S177-07/08

2103.2, 2103.8, Table 2103.8(2), 2103.13 (New), 2103.13.4, 2106.13.6, Chapter 35 (New)

Proponent: Jason Thompson, National Concrete Masonry Association, representing Masonry Alliance for Codes and Standards

**FIGURE 2109.4.1
GRAPHICAL REPRESENTATION OF W_S AND W_T**

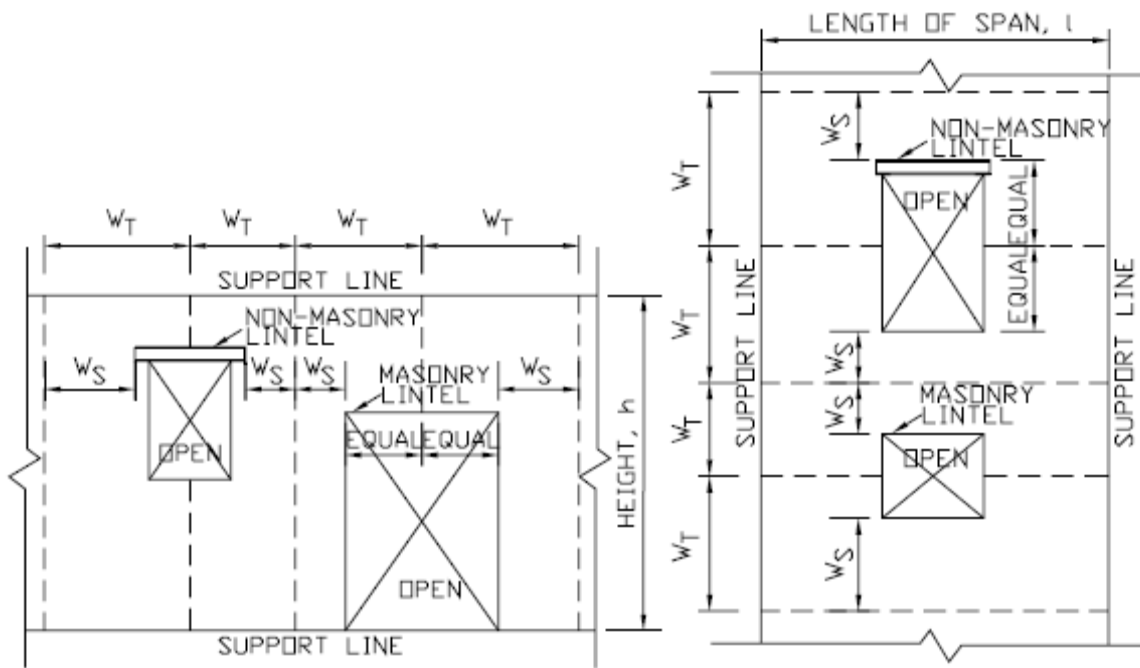
2109.4.1 Intervals Maximum l/t and h/t . Masonry walls without openings shall be laterally supported in either the horizontal or vertical direction such that l/t or h/t does not exceed the values given in Table 2109.4.1. Masonry walls with single or multiple openings shall be laterally supported in either the horizontal or vertical direction such that l/t or h/t does not exceed the values given in Table 2109.4.1 divided by $\sqrt{W_T/W_S}$.

W_S is the dimension of the structural wall strip measured perpendicular to the span of the wall strip and perpendicular to the thickness as shown in Figure 2109.4.1. W_S is measured from the edge of the opening. W_S shall be no less than $3t$ on each side of each opening. Therefore, at walls with multiple openings, jambs shall be no less than $6t$ between openings. For design purposes, the effective W_S shall not be assumed to be greater than $6t$. At non-masonry lintels, the edge of the opening shall be considered the edge of the non-masonry lintel. W_S shall occur uninterrupted over the full span of the wall.

W_T is the dimension, parallel to W_S , from the center of the opening to the opposite end of W_S as shown in Figure 2109.4.1. Where there are multiple openings perpendicular to W_S , W_T shall be measured from the center of a virtual opening that encompasses such openings. Masonry elements within the virtual opening must be designed in accordance with Section 2107 or 2108.

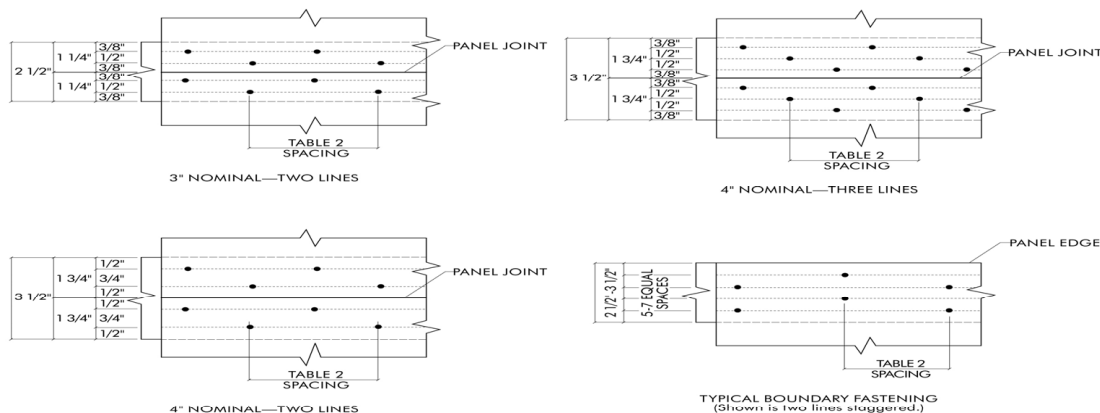
When the table was added to the IBC, the figures at the bottom of the table were inadvertently left out. The figures give diagrams of the various multi-row nail applications showing required spacing and staggering. These construction details provide clarity to the table and are essential to develop the values listed in the table. These figures have been part of this table for over two decades.

NOTE: SPACE PANEL END AND EDGE JOINT 1/8-INCH. REDUCE SPACING BETWEEN LINES OF NAILS AS NECESSARY TO MAINTAIN MINIMUM 3/8-INCH FASTENER EDGE MARGINS, MINIMUM SPACING BETWEEN LINES IS 3/8-INCH

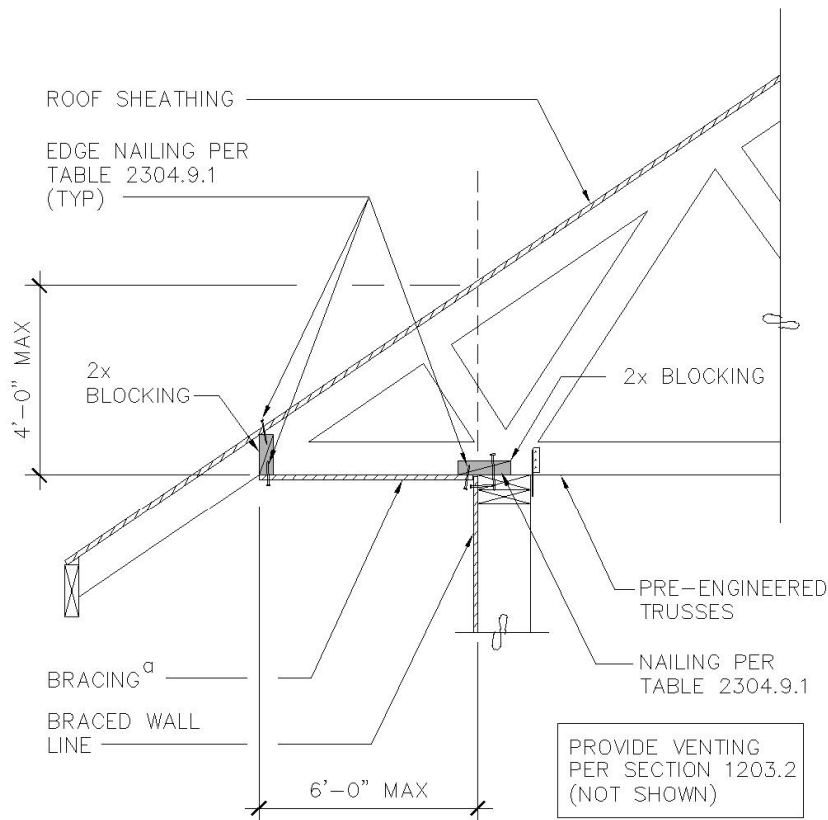
2308.3.2.2 Braced wall panel connections to roof framing. Braced wall panels shall be connected to roof framing as follows:

1. A parallel framing member or partial-height solid blocking between perpendicular trusses or rafters shall be provided and extend from the top plate to within 2 inches of the bottom side of the roof sheathing. Blocking shall be nailed to the top plate below with not less than 3-8d toenails per block.

FIGURE 2308.3.2 (1)
BRACED WALL PANEL TOP PLATE CONNECTION.

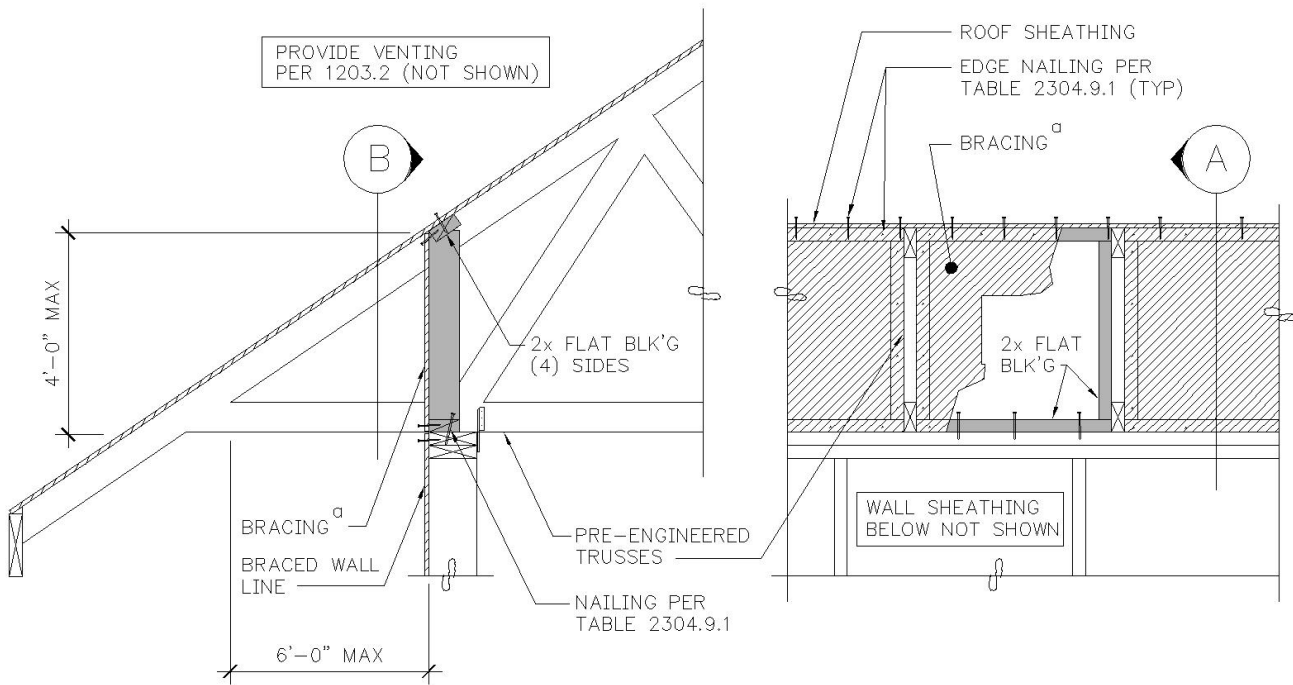
- 2.1. In accordance with Figure 2308.3.2 (1)
 - 2.2. In accordance with Figure 2308.3.2 (2)
 - 2.3. With full height engineered blocking panels designed for values listed in American Forest and Paper Association (AF&PA) *Wood Frame Construction Manual for One- and Two-Family Dwellings* (WFCM). Roof or floor sheathing above shall be attached to the blocking panels and the blocking panels shall be attached to top of wall in accordance with Table 2304.9.1

a. Methods of bracing shall be as described in Section 2308.9.3 methods 2, 3, 4, 6, 7 or 8
